EEE for Real-Time Industrial Ethernet (?)

Joachim W. Walewski,
Vivek Kulkarni, and Guenter Steindl
Siemens AG
Germany

See also our comment # 246

Retrofitting EEE for RE

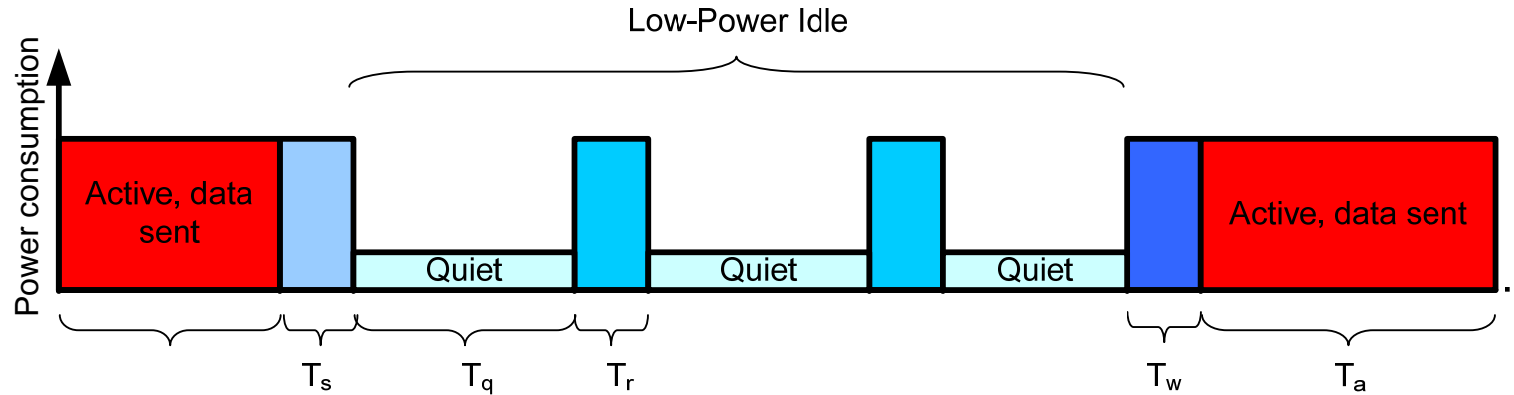
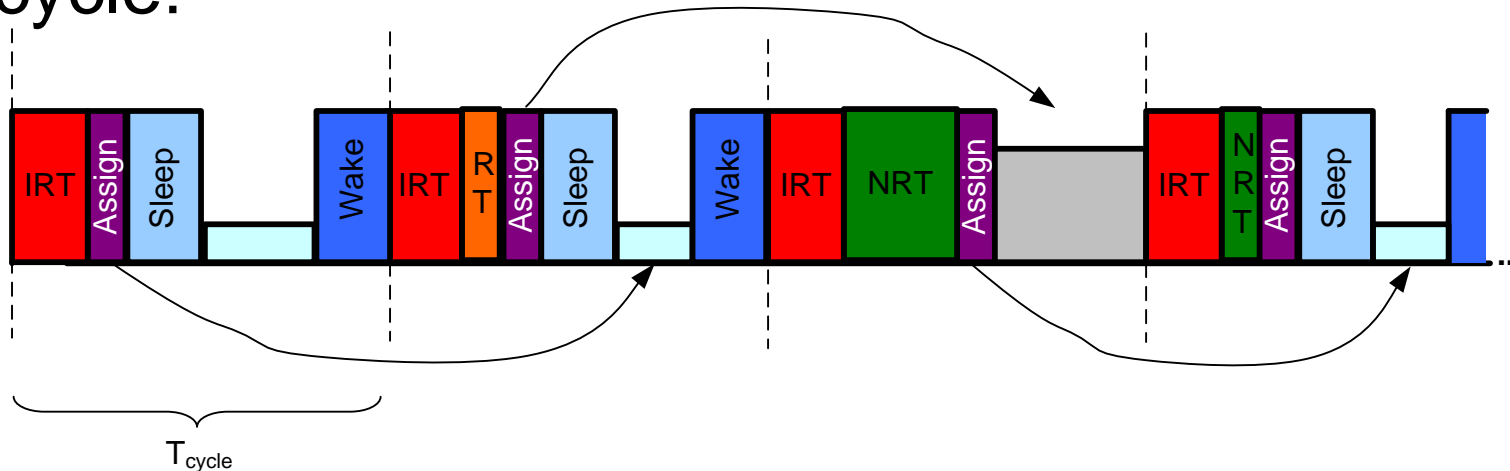
- Target data rates: FE, GE, (10-GE)
- Make quiet time shorter
 - Currently 2.5 ms (1000BASE-X, Table 36–3a)
 - GE RE cycle times likely much shorter
- Make quiet time dynamically adjustable
- Make sleep and wake timer as short as possible
- Allocate quiet-time control to MAC or cross-layer
